**Application for an Oil Sands Mine,
Bitumen Extraction Plant, and Bitumen Upgrading
Plant in the Fort McMurray Area**

January 27, 2004

**REPORT OF THE JOINT REVIEW PANEL ESTABLISHED BY THE
ALBERTA ENERGY AND UTILITIES BOARD AND THE GOVERNMENT OF CANADA**
EUB Decision 2004-005: Canadian Natural Resources Limited, Application for an Oil Sands Mine,
Bitumen Extraction Plant, and Bitumen Upgrading Plant in the Fort McMurray Area
January 27, 2004

Figure 1. Horizon oil sands project area

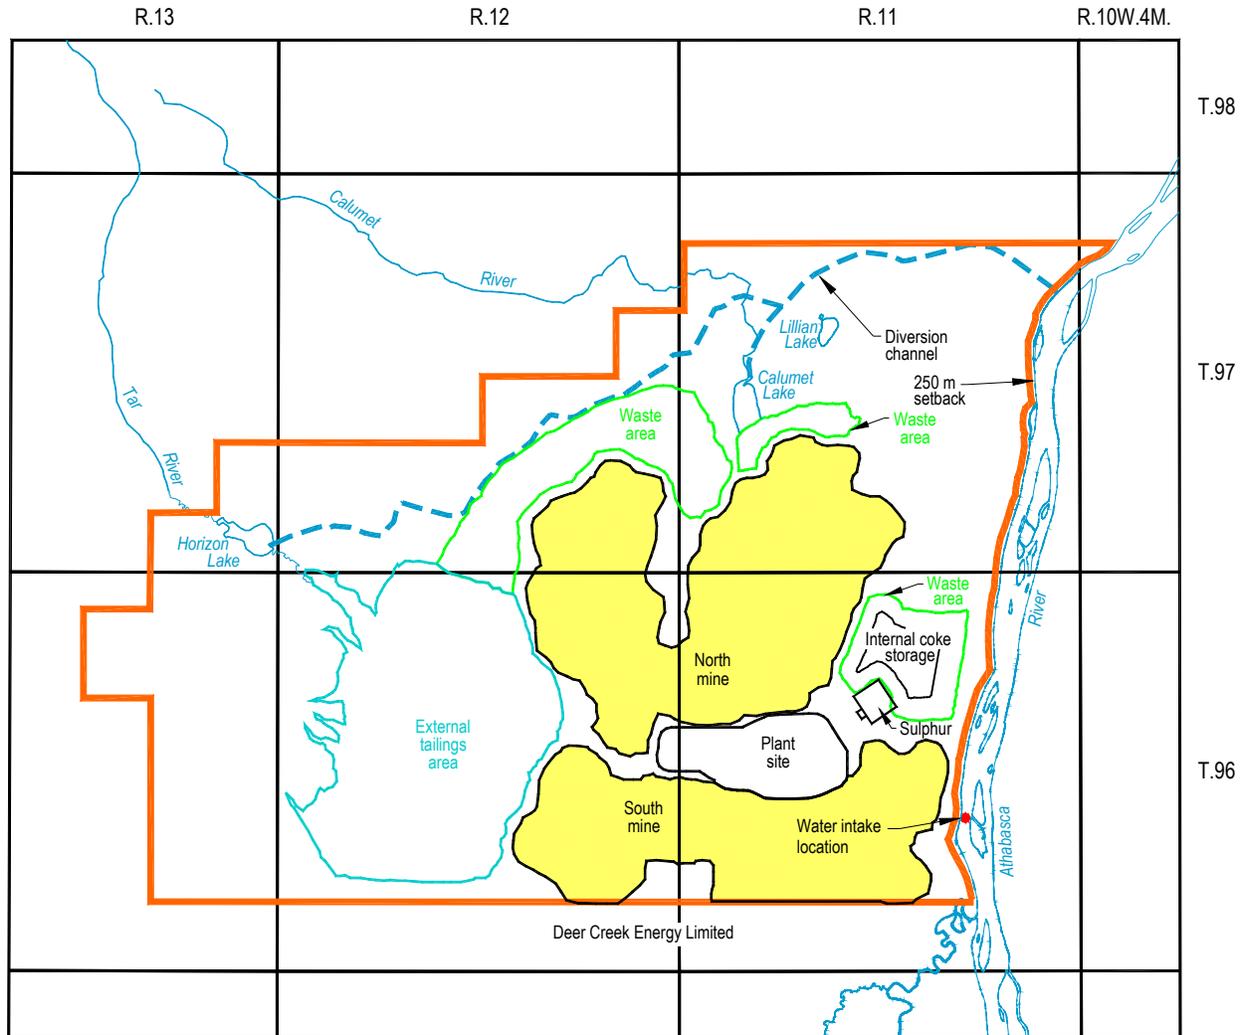
As a result of the concerns regarding foundation conditions, CNRL relocated its proposed plant site northward to the location shown on Figure 1. CNRL believed that the new plant site location would address the geotechnical concerns associated with the originally proposed site, since Clearwater clays were absent in portions of the new location. It recognized that construction of the plant in the new location would result in the sterilization of approximately $53.9 \times 10^6 \text{ m}^3$ of recoverable bitumen, $11.4 \times 10^6 \text{ m}^3$ more than the original site. However, CNRL indicated that its analysis showed that the additional costs associated with the original plant site exceeded the value of the additional foregone bitumen resources associated with the new plant site.

The Panel therefore finds that CNRL has justified the additional resource sterilization beneath the new plant site. Notwithstanding the overall acceptance of the proposed plant site, the Panel believes that since the layout of the plant site facilities remains to be finalized, some reduction in size may be realized through optimization of facilities. It therefore directs that six months prior to the construction of the plant site, CNRL shall submit a report to satisfy the EUB that all reasonable efforts have been made to optimize the plant site area with respect to the minimization of resource sterilization. The Panel notes that any additional oil sand sterilization resulting from an increase to the plant site area would require prior EUB approval.
